25 January 2019

Re: DA2018/2060 – Construction of a dwelling house at 43 Herbert Ave Newport

SITE PLAN  
SCALE 1:100

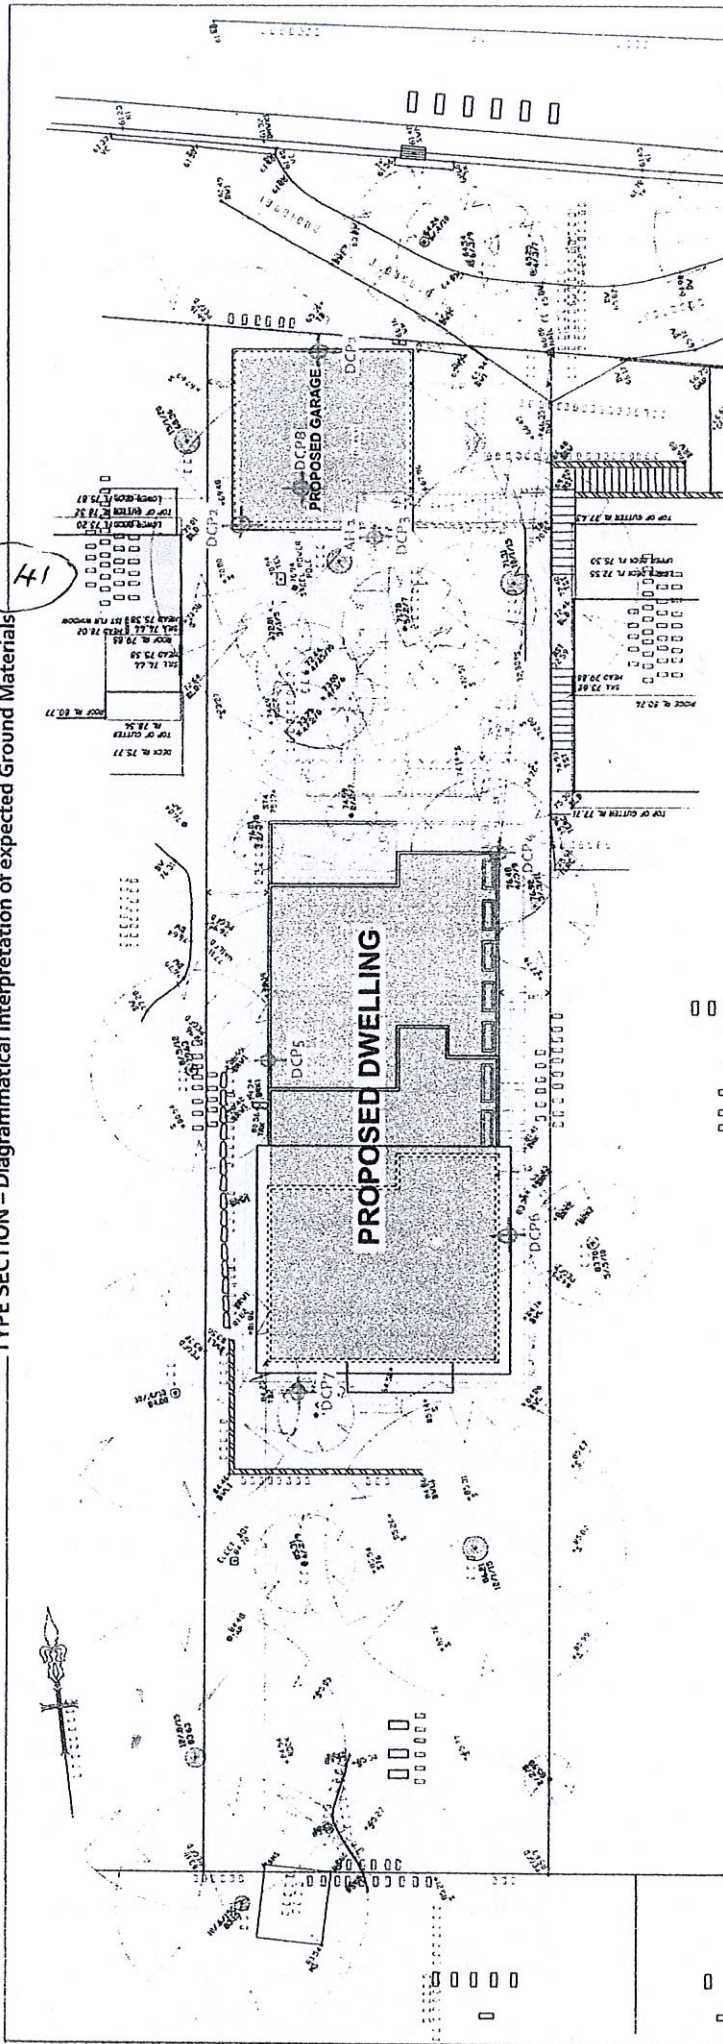
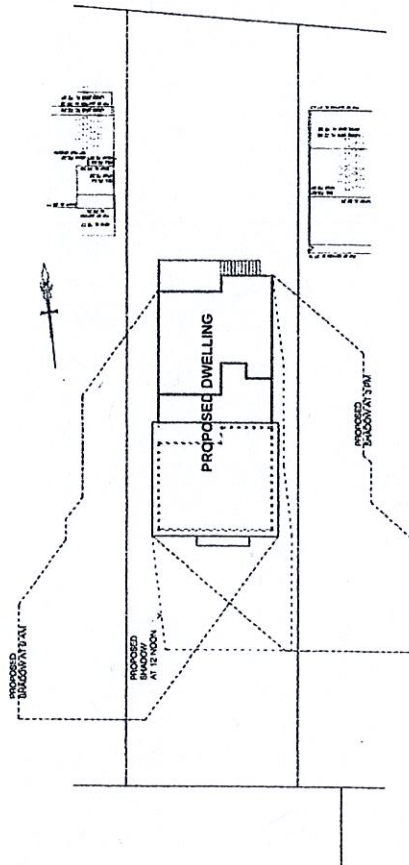
This latter drawing appears similar to one submitted for DA271/16 (withdrawn) { Refer attachment A.}
